# Determination 2024/070

**An authority's decision to refuse to issue a code compliance certificate in relation to a hedge and safety from falling**

**30D Lazarette Loop, Gleniti, Timaru**

**Figure 4: Diagram of the site layout, not to scale**

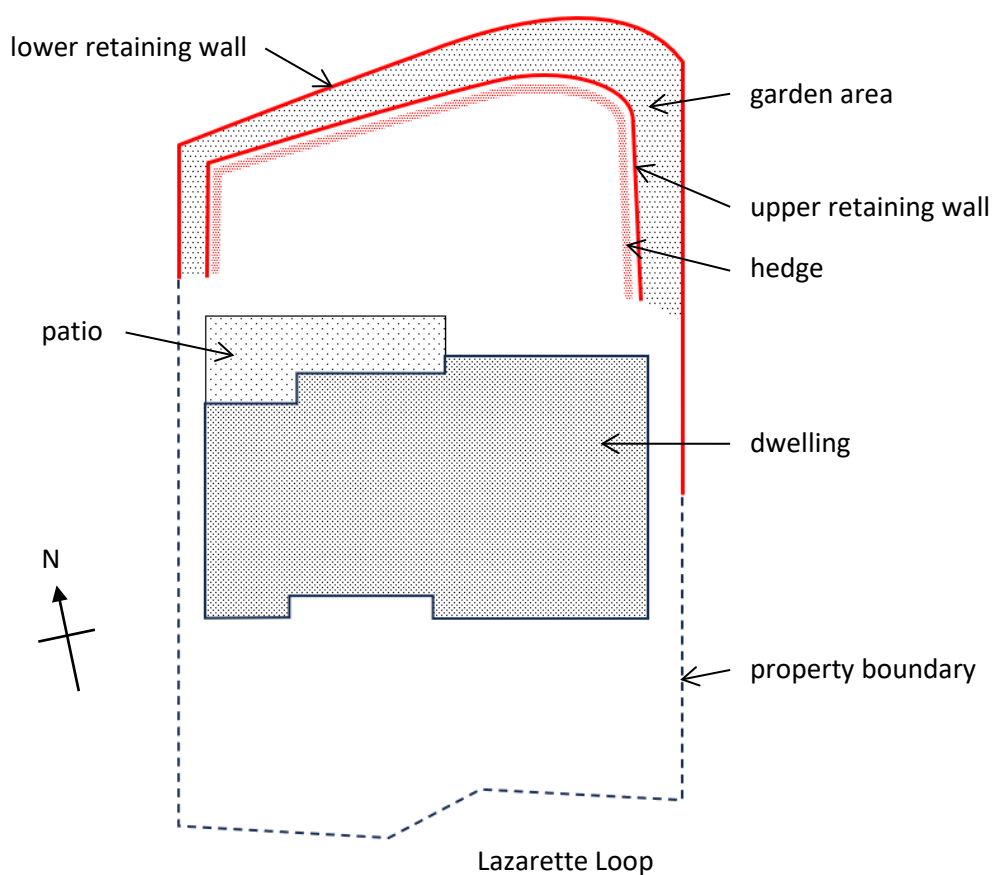
5.6. The sudden change in level occurs at the rear of the backyard, between 12 and 16 metres away from the dwelling. The dwelling opens out onto the patio and backyard, and the area is landscaped so that it is level from the dwelling across to the retaining walls.

5.10. The upper wall bounds the northern edge of the back yard to the dwelling, which as noted above is an area that people will access from the dwelling and utilise for recreation and leisure. The hedge as it currently stands limits access to the top of the retaining wall along its length. However, it is reasonably foreseeable that future owners of the property may change the landscaping to the back yard, including the removal of the hedge, with the effect of increasing the likelihood of an accidental fall from the upper retaining wall.

- 6.1. In accordance with section 188 of the Building Act 2004, I determine that:
- 6.1.1. the change in level at the upper retaining wall is associated with the dwelling and is required to have a barrier for the dwelling to comply with clause F4.3.1

- 6.1.2. the hedge does not satisfy the requirements of Building Code Clause F4  
*Safety from falling*
- 6.1.3. and I confirm the authority's decision to refuse to issue a code compliance  
certificate for BC 2.2019.185.1.

**Figure 5: Section diagram layout, not to scale**

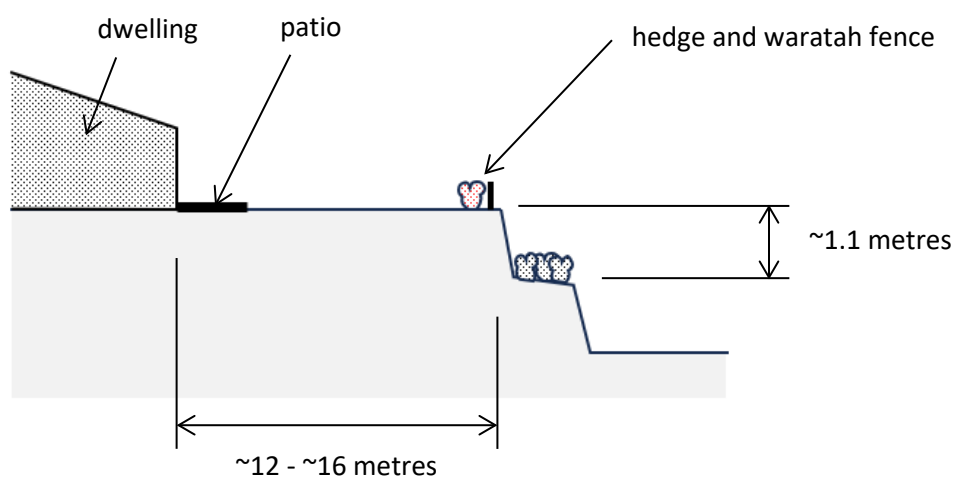
- 2.4. The upper retaining wall is generally 1.1 metres in height along its northern section.
- 2.5. The northern section of the upper retaining wall is approximately 12 metres at its closest to the dwelling, and 16 metres at its farthest.

5.11. I therefore conclude there is a reasonable probability that people will or could be on or in close proximity to the top of the upper retaining wall, such that there is likelihood of accidental fall. Therefore, the functional requirement of clause F4.2 applies, and as the sudden change in level is associated with the dwelling it must be constructed to reduce the likelihood of that accidental fall from it. This would involve the construction of a barrier which meets the performance requirements of clauses F4.3.1 and F4.3.4.
